TECHNICAL BULLETIN

407-14-108

MODEL AFFECTED: 407

SUBJECT: GSC46 Engine Signal Conditioner, Improvement of

Figure 1 – GSC46 Engine Signal Conditioner Installation

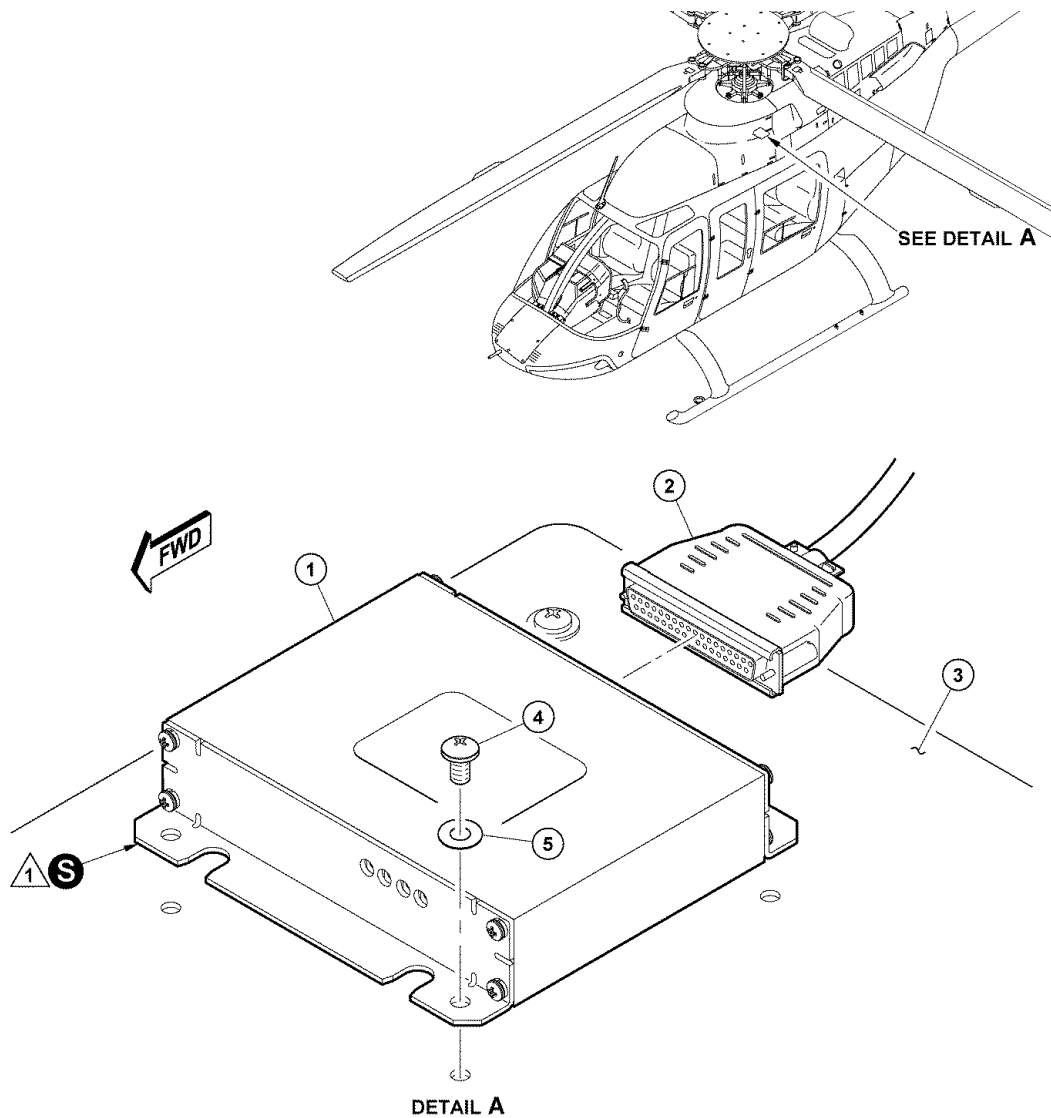
2. Gain access to the GSC46 Engine Signal Conditioner (BHT-407-MM-3, Chapter 25, and Figure 1).
3. Remove the affected GSC46 Engine Signal Conditioner (BHT-407-MM-10, Chapter 95).

NOTE
1 After installation of the engine signal conditioner (1), apply sealant (C-251) to seal the edges of the electrical bonding area.

4. Install the GSC46 “MOD 3” Engine Signal Conditioner (BHT-407-MM-10, Chapter 95).
5. Reinstall the hat bin if previously removed in step 2 (BHT-407-MM-3, Chapter 25).
6. Power the helicopter 28VDC system and verify on the PFD (Primary Flight Display) for the following:
 - a. CAS (Crew Alerting System) message “ALTN” in amber is not displayed above the PSI (Power Situation Indicator).
 - b. CAS (Crew Alerting System) message “ALTN DATA FAIL” in white is not displayed within the CAS window.
7. Make an entry in the helicopter logbook and historical service records indicating compliance with **Part II** of this Technical Bulletin.

Figure 2 – GSC46 Engine Signal Conditioner Data Plate

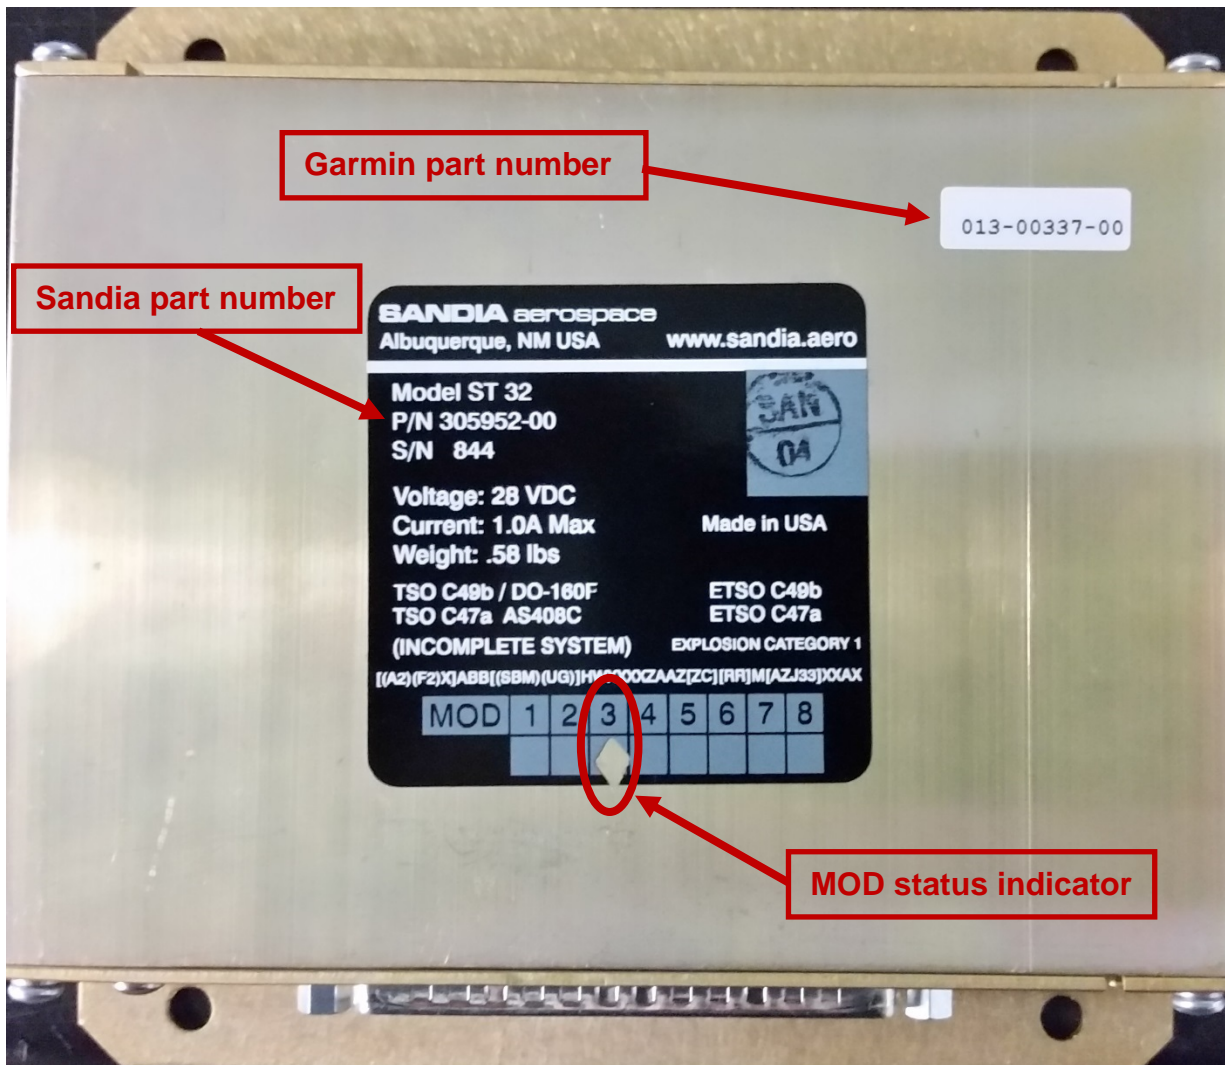
2. Gain access to the GSC46 Engine Signal Conditioner (BHT-407-MM-3, Chapter 25, and Figure 1).
3. Verify the MOD status on the identification plate of the GSC46 Engine Signal Conditioner. If the identification plate is not **MOD 3**, as seen in Figure 2, then accomplishment of **Part II** of this bulletin is required, otherwise no further action is required.
4. Make an entry in the helicopter logbook and historical service records indicating compliance with **Part I** of this Technical Bulletin.

A GSC46 Engine Signal Conditioner (013-00337-00 or 013-N0337-00) with the latest improvements incorporated will be stamped with a “MOD 3” identification (Figure 2).
